# **PLANNING COMMISSION**

## **AGENDA REPORT**

**SUBJECT: AN AMENDMENT TO MASTER PLAN PA-10-26 A1 FOR COMMERCIAL DEVELOPMENT AND TENTATIVE PARCEL MAP 2010-135 FOR SUBDIVISION AT 3135, 3141, 3151, 3161, 3181, AND 3195 HARBOR BLVD.**

**EXHIBIT "A" GISLER AVE**

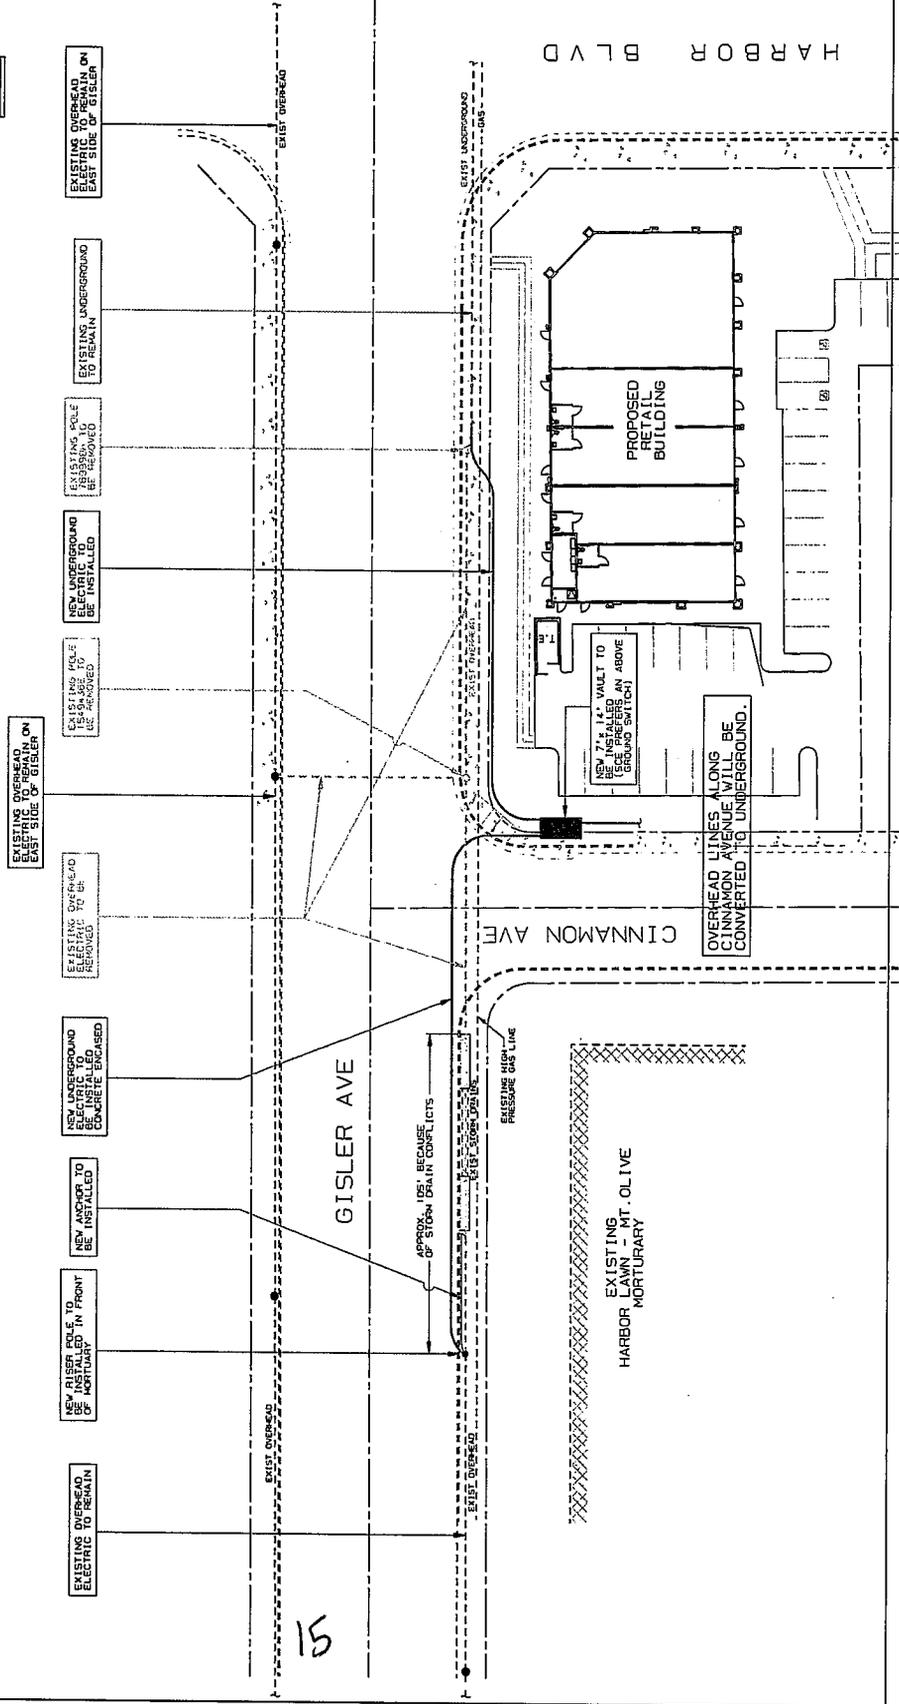
- Conversion of the overhead lines along Gisler Avenue would require the installation of a new riser pole, anchor and guy wires north of Cinnamon Ave. There are storm drain facilities that prevent the installation of these facilities close to the intersection. The new pole would have to be installed approximately 105 feet north of the curb return as shown on Exhibit "A". This places the new pole in front of the entrance to the Mortuary. The pole needs to be set approximately 40 feet north of an existing catch basin to allow for a new anchor and guy wire. SCE was concerned about placing a new pole and anchor in front of the Mortuary entrance. The net result would be to remove only one pole on Gisler Ave.

- The trenching along Gisler Avenue north of Cinnamon Ave would have to be done within the street because of the existing storm drain facilities and an existing high pressure gas line within the parkway. Concrete encasement would be required for the duct system.

- Conversion of overhead lines can fall under two different rules, Rule 20B or Rule 20C. Under Rule 20B SCE gives a credit for an equivalent overhead system and removes all of the overhead facilities at their cost. Under Rule 20C the applicant receives no credits and is billed for all the removals. To qualify for Rule 20B, both sides of the street must be converted. If Gisler Ave is included in the conversion, SCE would design the entire conversion (Cinnamon Ave and Gisler Ave) under Rule 20C since only one side of Gisler Ave is being converted. This would greatly increase the cost to the applicant. If only Cinnamon Ave is converted, the conversion falls under Rule 20B.

- Converting the overhead lines along Gisler Avenue would require a large Vault (7' x 14') to be placed within the landscape area along Cinnamon Ave at the intersection. SCE would prefer an above ground switch at this location. A smaller vault (5' x 8'6") with no switch requirement would be installed if only Cinnamon Avenue is converted. With no switch requirement, there would not be the possibility of an above ground switch that would create a visual impact.

Please refer to the two exhibits provided for reference. Exhibit "A" shows the condition of converting the overhead electric lines along Gisler Avenue. Exhibit "B" shows the condition of leaving the overhead line along Gisler Avenue.

62. All above ground utility lines on Cinnamon Avenue and ~~Gisler Avenue~~ shall be undergrounded. Amended August 8, 2011
